January 11, 2000

SUBJECT: REPORT OF CONFIRMATORY ACTIVITIES FOR THE QUIVIRA MINING COMPANY-AMBROSIA LAKE FACILITY WINDBLOWN TAILINGS DECOMMISSIONING PROGRAM, GRANTS, NEW MEXICO (DOCKET NO. 40-8905; RFTA NO. 99-041)

**REPORT OF CONFIRMATORY ACTIVITIES FOR THE
QUIVIRA MINING COMPANY-AMBROSIA LAKE FACILITY
WINDBLOWN TAILINGS DECOMMISSIONING PROGRAM
GRANTS, NEW MEXICO**

FIGURE 4: Quivira Mining Company – Surveyed Areas

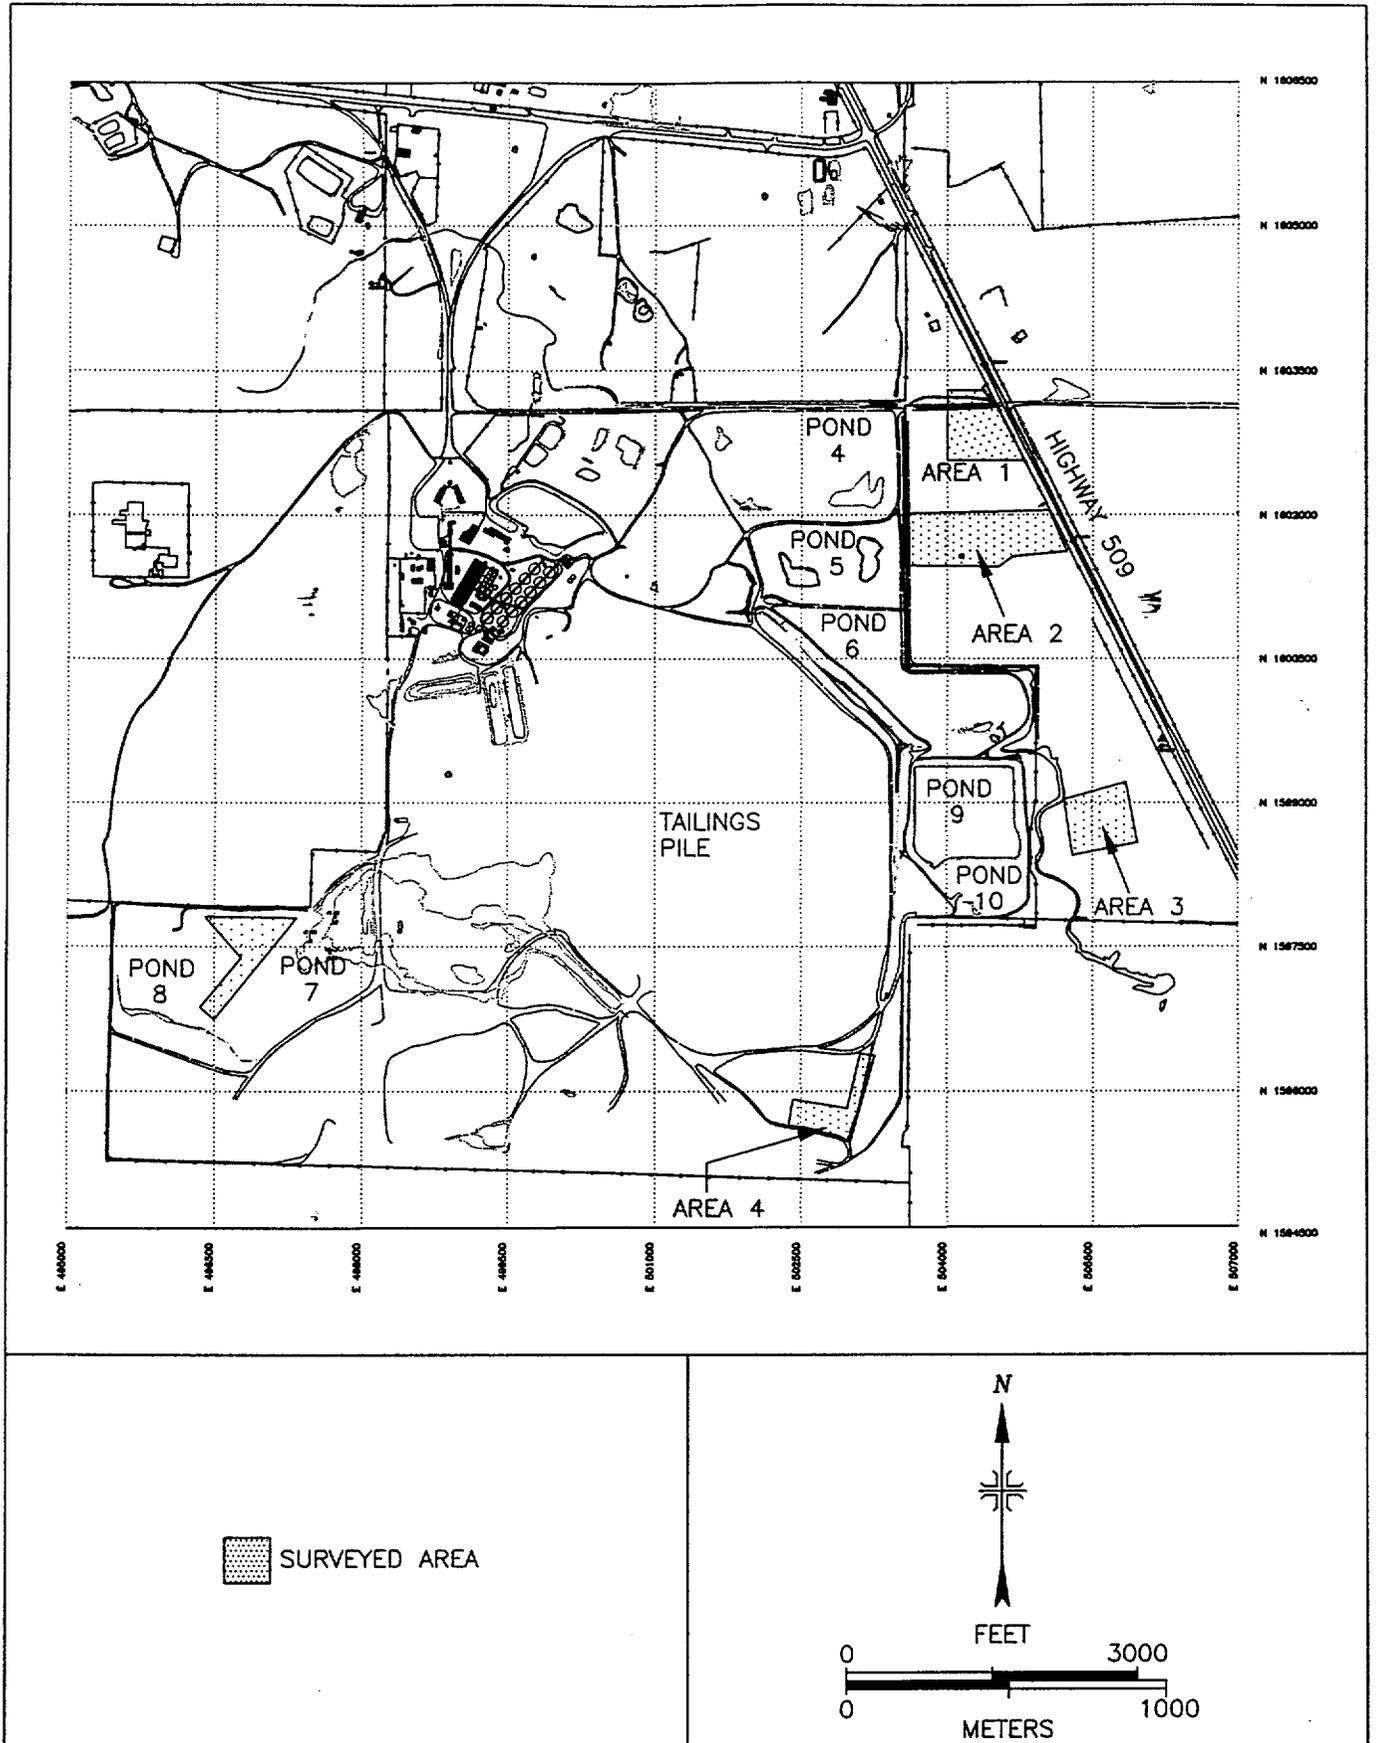
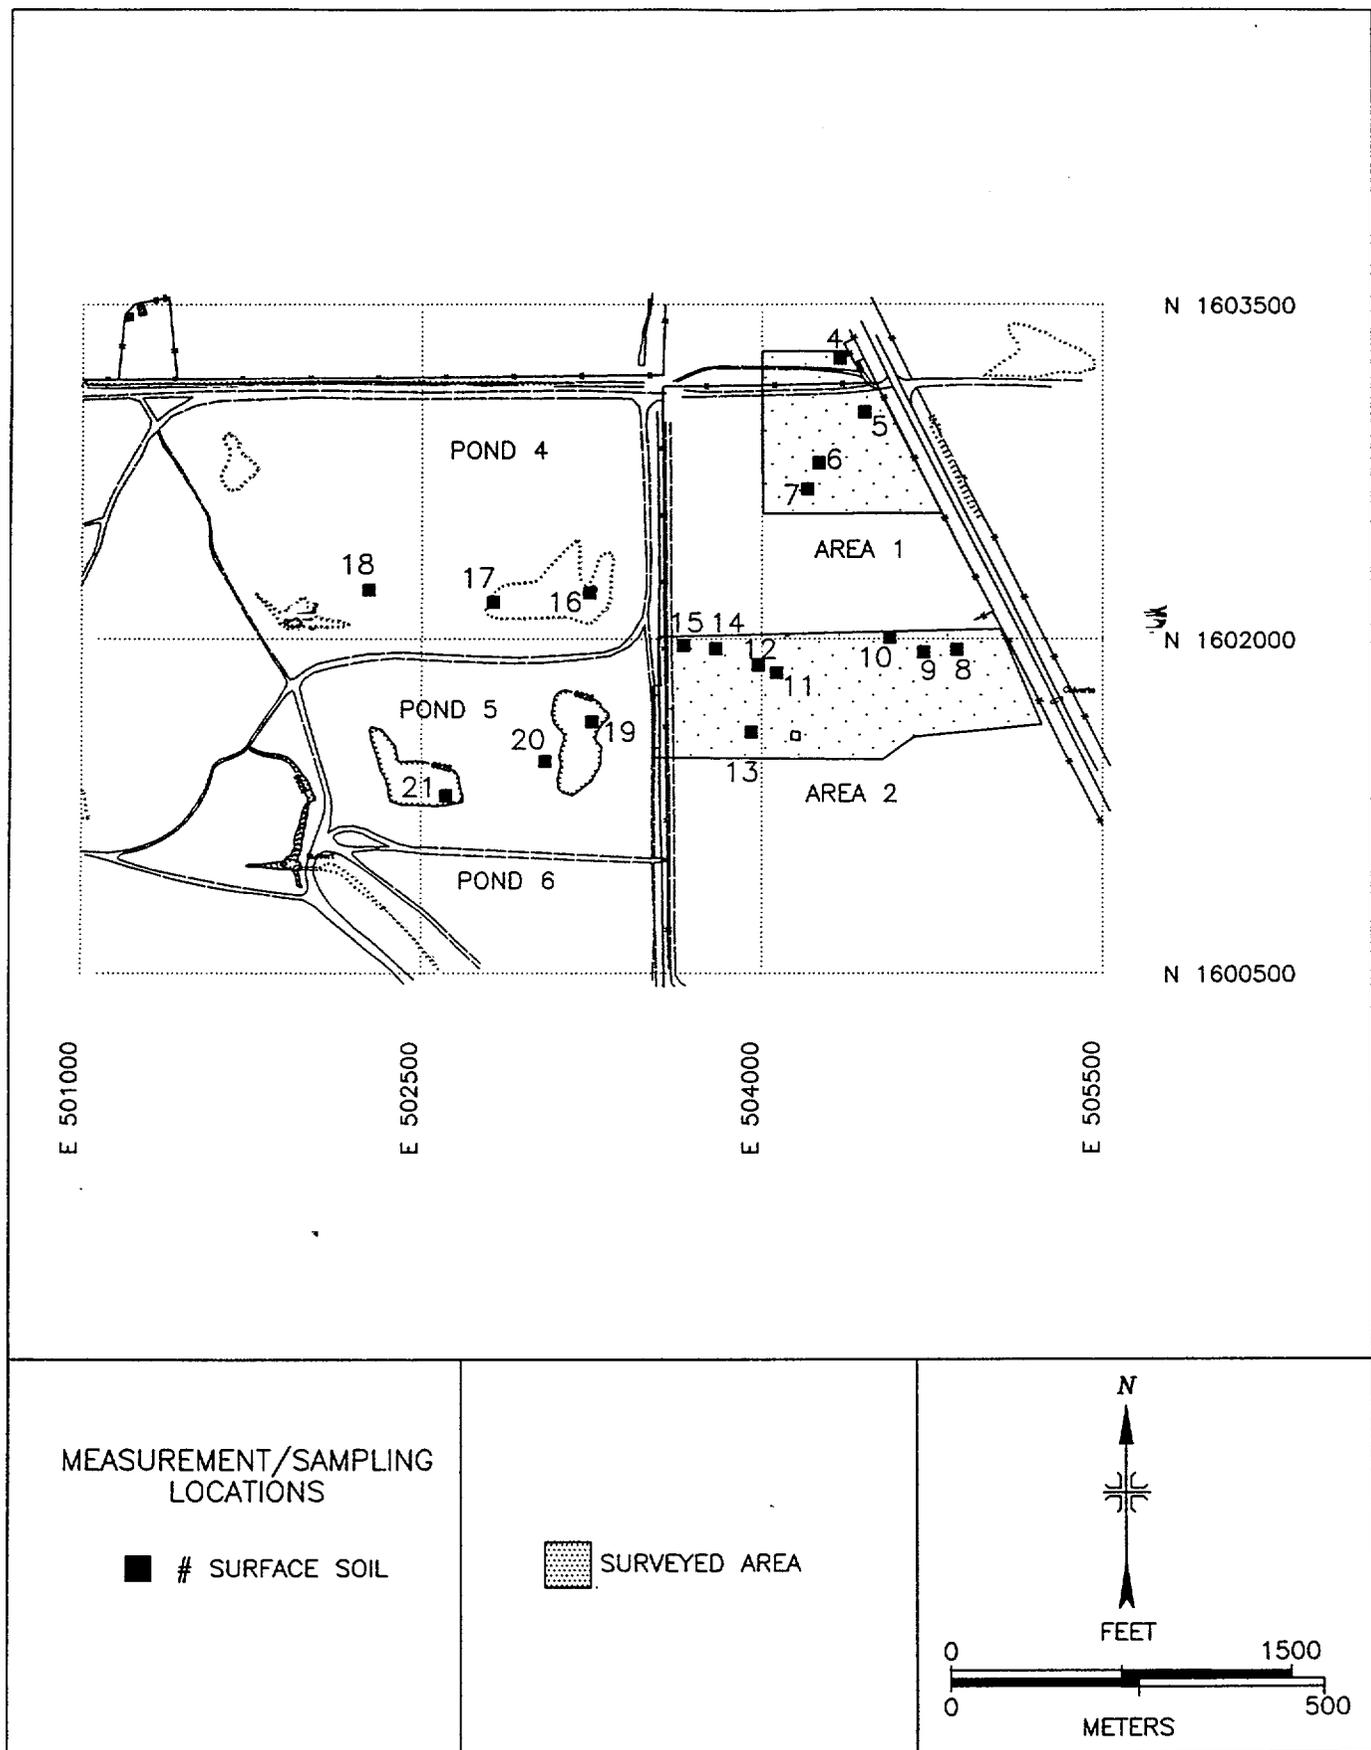
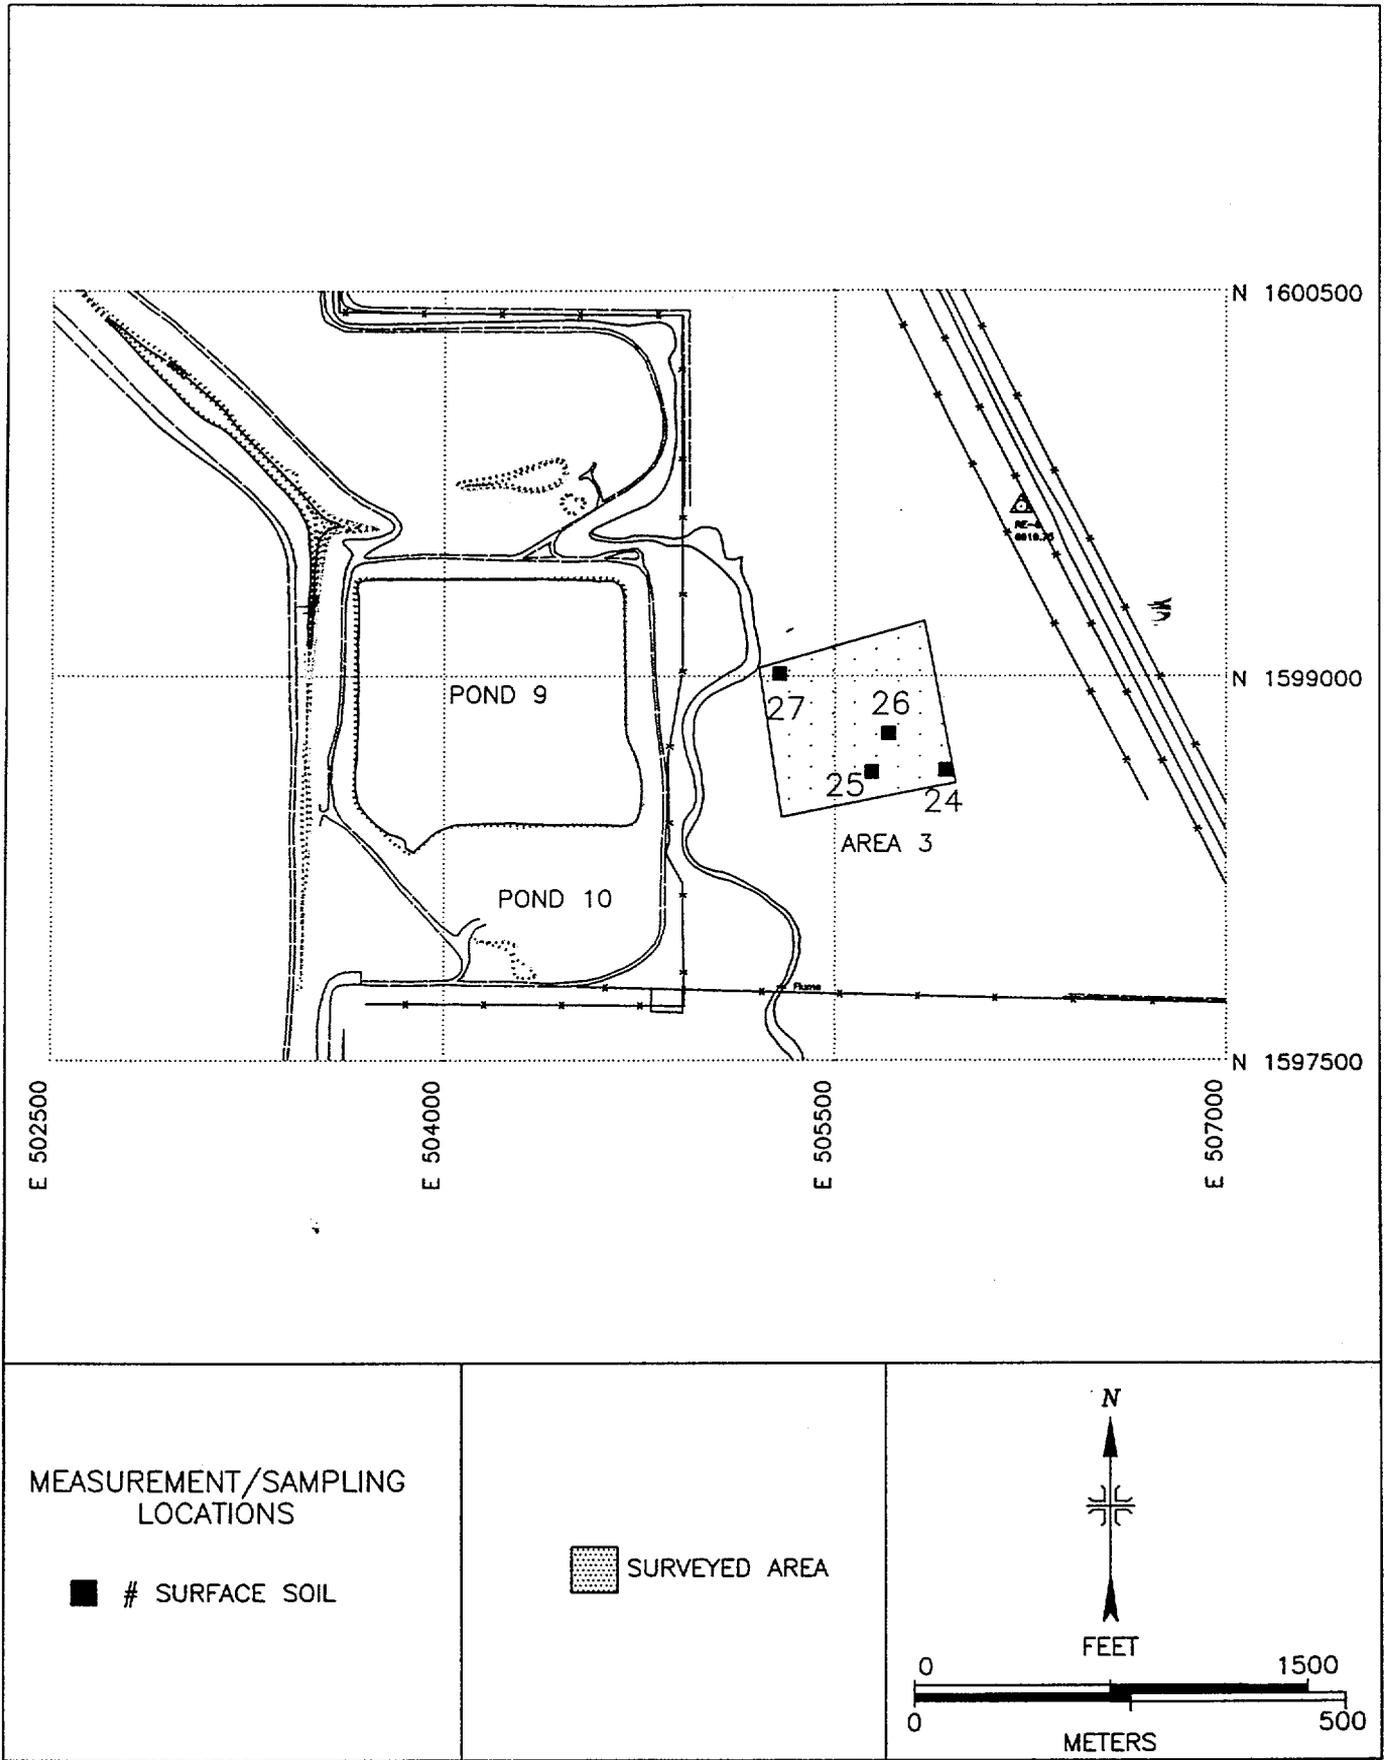
- Confirmatory gamma surveys were performed over four windblown tailings areas. Surveyed areas are shown on Figures 4 through 7. Surveys of these areas consisted of gamma surface scans using NaI scintillation detectors coupled to ratemeters with audible indicators. The distance between the detector and the ground surface was maintained at a minimum—nominally about 10 centimeters. Within each area surveyed, parallel one meter-wide detector scan paths were traversed for the entire length of the area. Scan paths were walked at intervals of every 10 to 20 meters across each surveyed area. Areas of elevated direct radiation in excess of the ambient background by a factor of greater than two times were marked and 100 % of the surrounding area was scanned. There were numerous such areas identified while performing the gamma scans. Sixteen representative anomalous areas identified were then selected for soil sampling. Samples were collected from the center of each selected anomaly and from four points equidistance between the center and what would be the corners of a 10 m × 10 m area, and field composited. Within Ponds 4, 5, and 8, general area gamma measurements were made while traversing each pond from end-to-end. General elevated gamma activity up to 10 times ambient background was noted throughout each of the ponds. Composite soil samples as described above were collected from three locations each in Ponds 4 and 5. For Pond 8 which had been remediated and backfilled, a composite sample was collected from one location at the surface (0 to 15 cm) and then a composite subsurface (15 to 30 cm) sample collected. Figures 5 through 7 show soil sampling locations. Exposure rate measurements were determined not to be required with the NRC representative's concurrence.
